**THIS BULLETIN IS FAA APPROVED FOR ENGINEERING DESIGN**

SUBJECT: Mooney Windscreen and Window Fastener Installation Procedure

MODELS/ SN  
AFFECTED: M20U Ovation Ultra - 32-0002  
M20V Acclaim Ultra - 33-0002 and 33-0003

Figure SB M20-329-1 - Hole Placement Around Outboard Perimeter of Windscreen

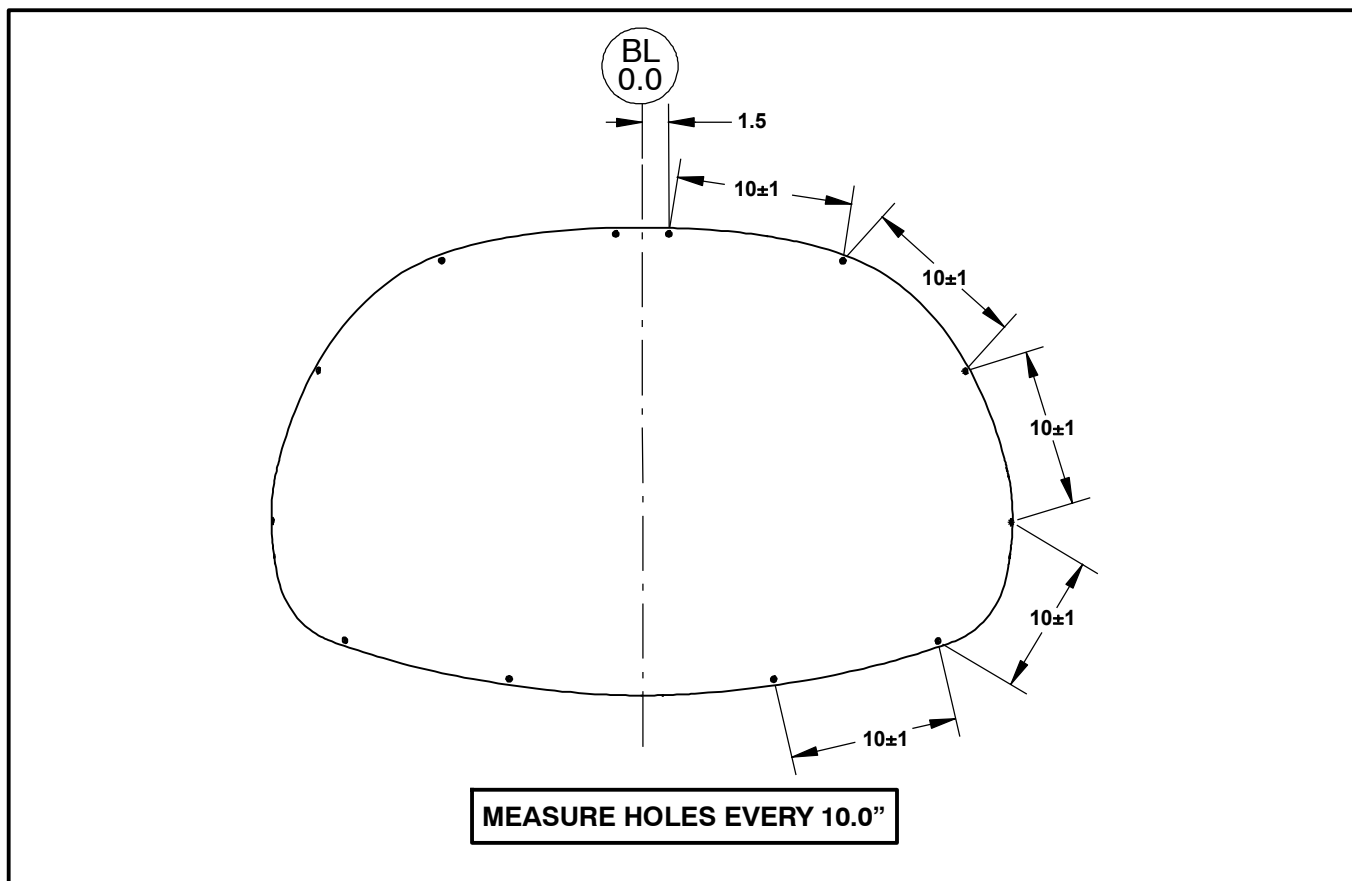
- 1.1. Remove upper and front post interior panels and glare shield from aircraft. Refer to the applicable Mooney Service and Maintenance Manual.
- 1.2. Starting from center butt line at the outboard top of the windscreen, measure 1.5 inches to the right and mark the first hole using masking tape or a similar method.

- Be a minimum distance of 0.75" from the rivet spacer in the shell flange.
- Be a minimum distance of 0.30" from the edge of the windscreen and flange.

Continue measuring around the outboard perimeter of the windscreen, marking off 5 additional holes every 10 inches. Refer to Figure M20-329-1.

- 1.3. Repeat step 1.2 to the left of the center butt line starting at the outboard top of the windscreen. A total of 12 holes should be marked off.
- 1.4. Using a BAT #40 HSS drill bit and a drill guide, carefully drill the 12 holes around the outboard perimeter of the windscreen and shell flange. Refer to Figure M20-329-3.

Figure SB M20-329-2 - Hole Placement Around Outboard Perimeter of Windows (LH Shown)

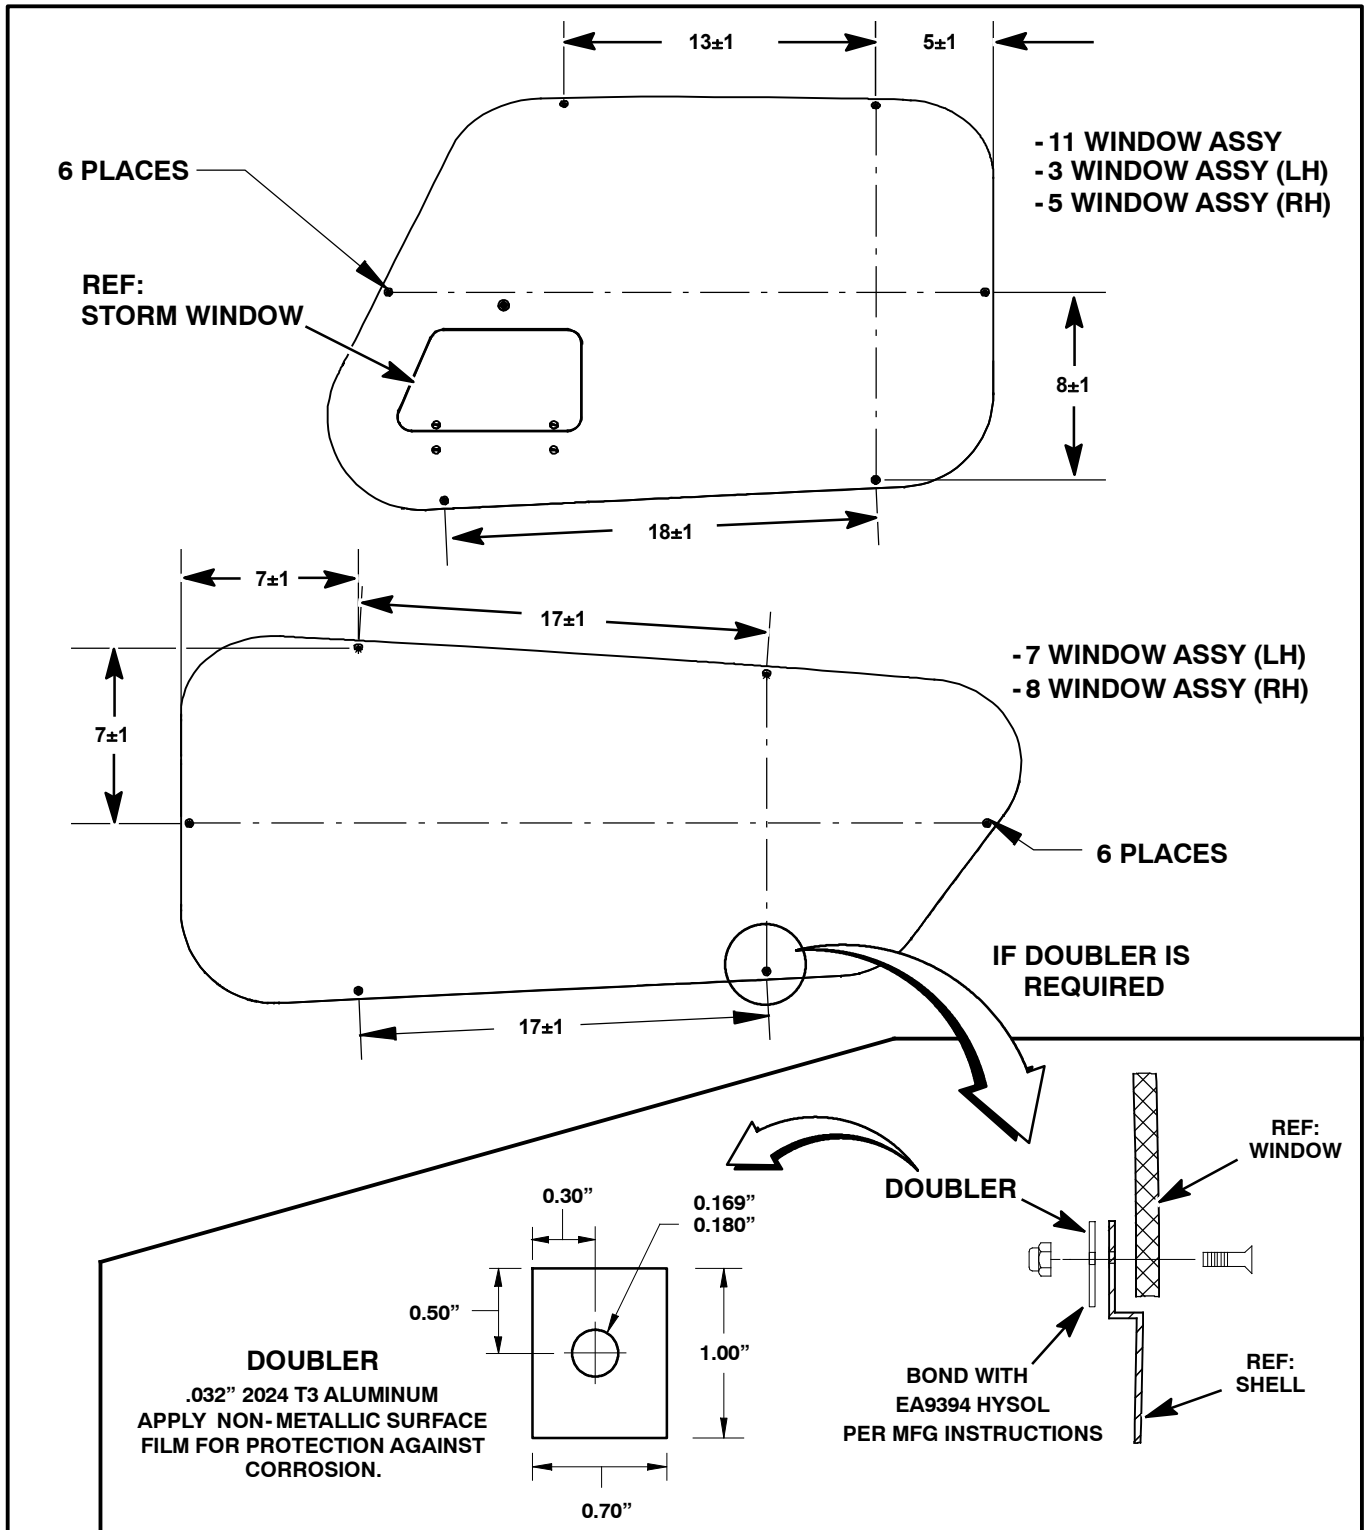
- 2.5. Using masking tape or a similar method, measure and mark the hole locations on the window. A total of 6 holes should be marked off per window. Refer to Figure M20-329-2 for hole locations and measurements.

- **Be a minimum distance of 0.750" from the rivet spacers in the shell flange.**
  - **Be a minimum distance of 0.300" from the edge of the window and flange.**
- However if distance is shorter:**
- **If edge distance is between 0.200" - 0.300" from the edge of the composite shell flange, a doubler will be required.**
  - **Anything less than 0.300" on window or 0.200" on composite flange is unacceptable and will need further action from Mooney International.**

- 2.5.1 If doubler is required, make from 0.032" thick 2024 T3 Aluminum and cut to 1.00" x 0.700" size, refer to Figure M20-329-2. Apply a non-metallic surface film (Chemical Conversion Coating) to doubler for protection against corrosion.

- 2.5.2 Bond doubler to inner window flange with EA9394 Hysol per manufacturers instructions and located such that the fastener hole is at least 0.300" from the edge of the doubler.

Figure SB M20-329-3 - Drill Bit Sequence

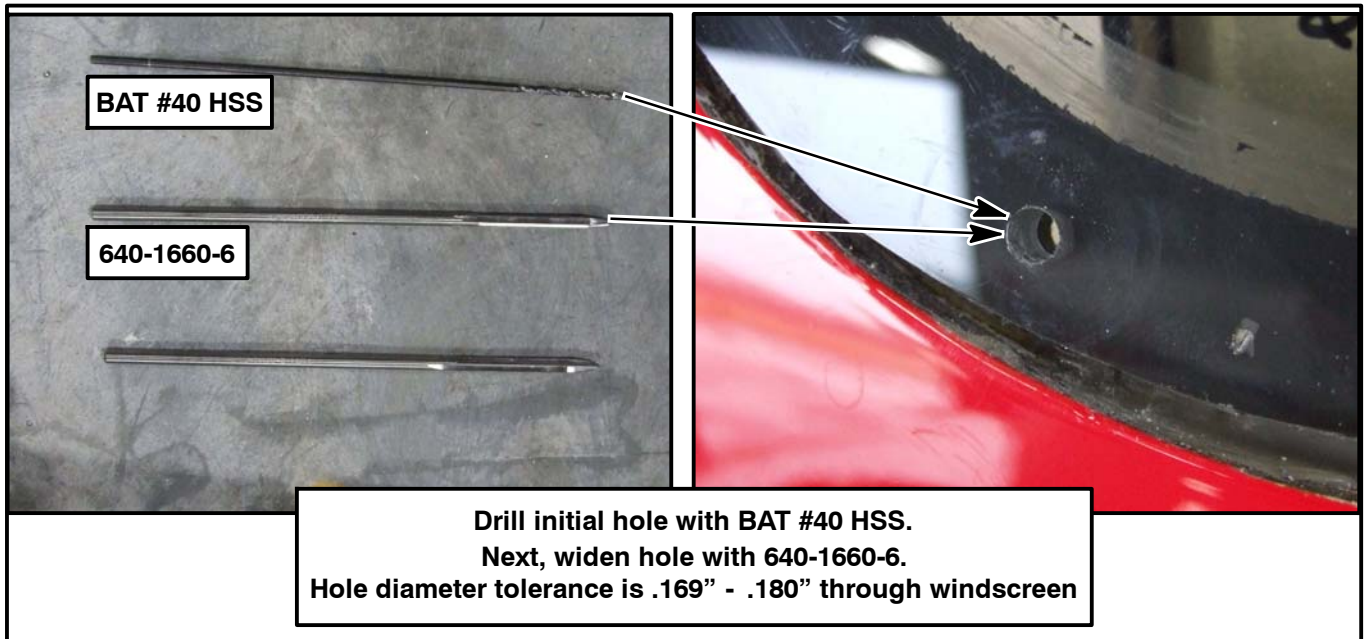
- 1.5. Using a 640-1660-6 drill bit and a drill guide, carefully enlarge the holes. Refer to Figure M20-329-3. Hole diameter tolerance is .169" - .189" through windscreen.

- 2.6. Using a BAT #40 HSS drill bit and a drill guide, carefully drill the 6 holes around the outboard perimeter of the window and shell flange. Refer to Figure M20-329-3.

- 2.7. Using a 640-1660-6 drill bit and a drill guide, carefully enlarge the holes. Refer to Figure M20-329-3. Hole diameter tolerance is .169" - .189" through windscreen.

Figure SB M20-329-4 - Drill Bit Sequence

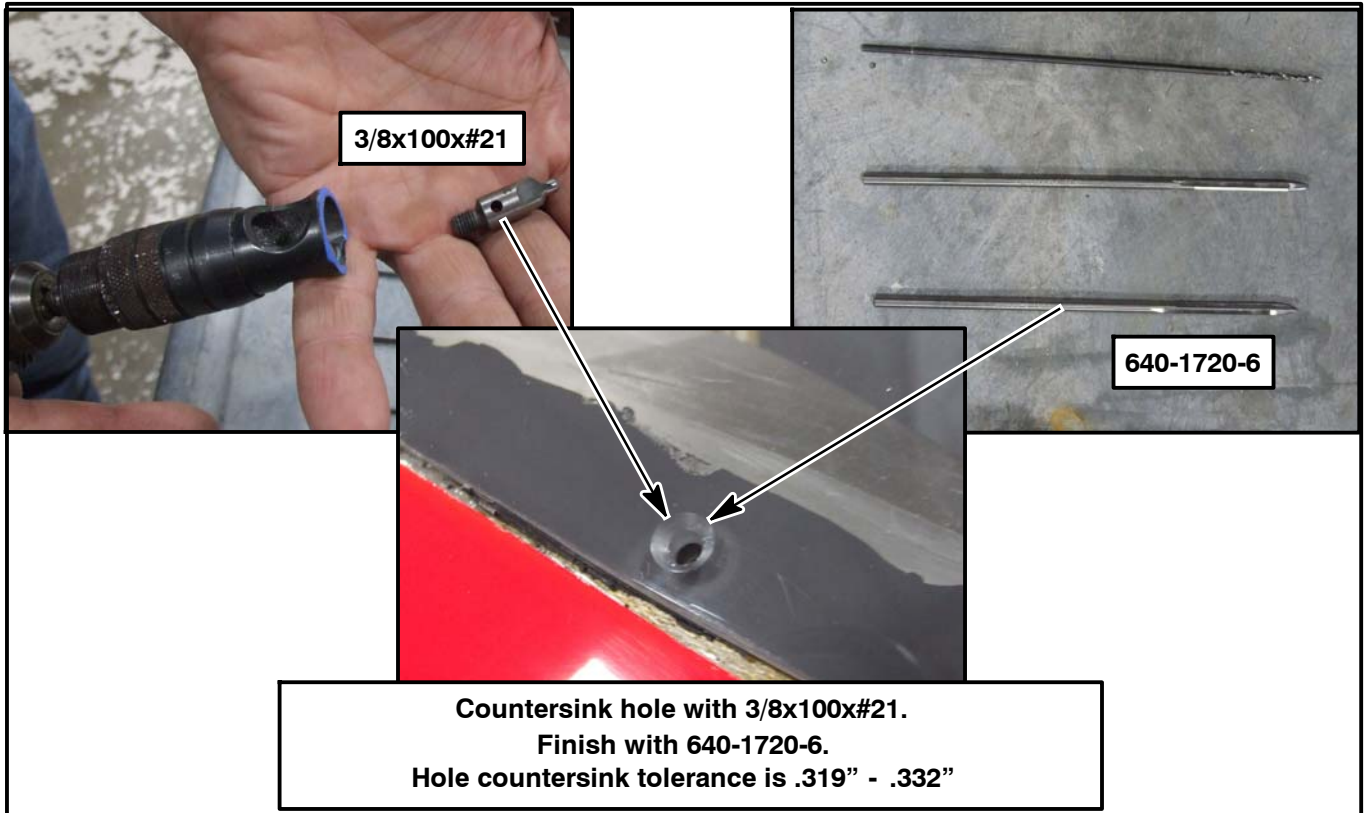
- 1.6. Using a 3/8x100x#21 countersink drill bit, carefully countersink the holes. Refer to Figure M20-329-4. Hole countersunk tolerance is .319" - .332" through windscreen.
- 1.7. Using a 640-1720-6 drill bit, carefully enlarge the holes. Refer to Figure M20-329-4.
- 1.8. Inspect the holes for signs of crazing, cracking, or chipping. If these signs are present, stop procedure and contact Mooney Technical Support.
- 1.9. Place a small bead of CS3204-B sealant around the underside of the head of the MS24694-S9 screws. Refer to Figure M20-329-5.
- 1.10. Using a Phillips head screwdriver, install the MS24694-S9 screws, the NAS1149FN832P washers, and MS21042L08 nuts, and lightly tighten by hand. Refer to Figure M20-329-5.
- 1.11. Lightly tighten the screws until snug to <3 in-lbs.

- 2.8. Using a 3/8x100x#21 countersink drill bit, carefully countersink the holes. Refer to Figure M20-329-4. Hole countersunk tolerance is .319" - .332" through windscreen.

- 2.9. Using a 640-1720-6 drill bit, carefully enlarge the holes. Refer to Figure M20-329-4.
- 2.10. Inspect the holes for signs of crazing, cracking, or chipping. If these signs are present, stop procedure and contact Mooney Technical Support.

Figure SB M20-329-5 - Hardware Installation

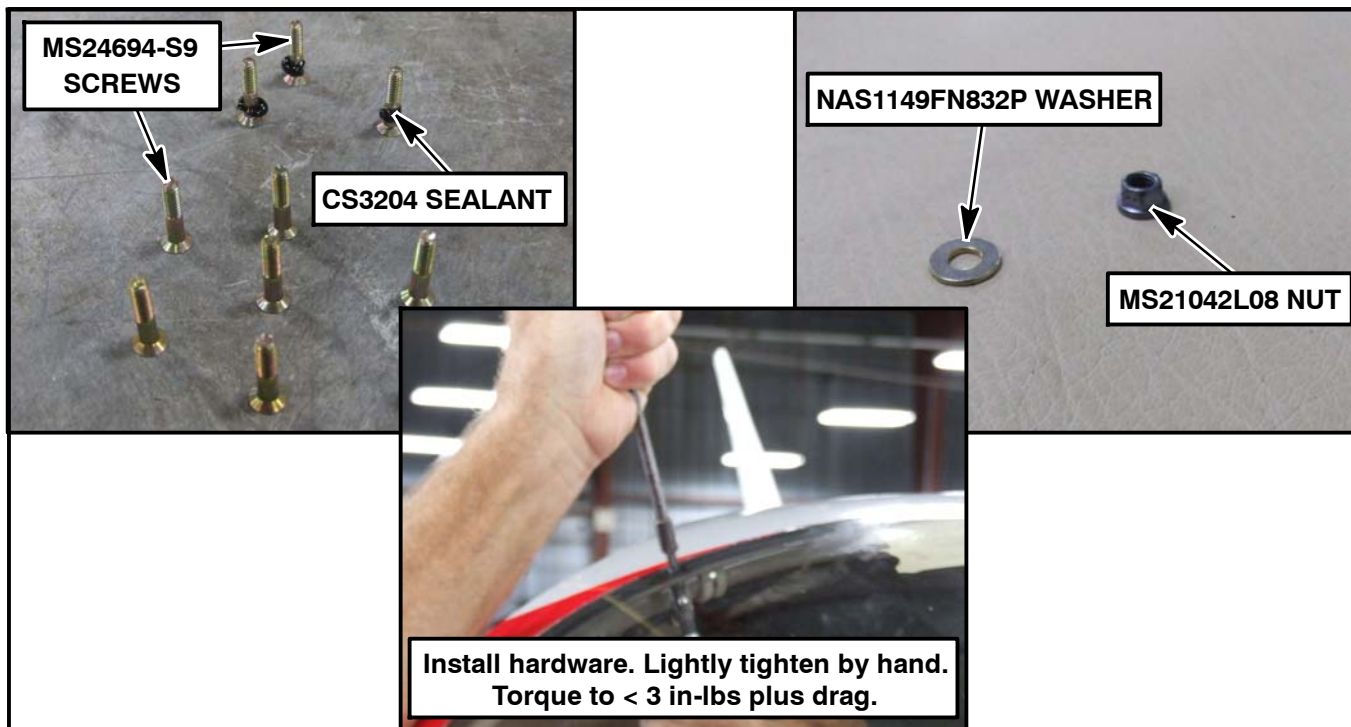
- 2.11. Place a small bead of CS3204-B sealant around the underside of the head of the MS24694-S9 screws. Refer to Figure M20-329-5.
- 2.12. Using a Phillips head screwdriver, install the MS24694-S9 screws, the NAS1149FN832P washers, and MS21042L08 nuts, and lightly tighten by hand. Refer to Figure M20-329-5.

- 2.13. Lightly tighten the screws until snug to <3 in-lbs.
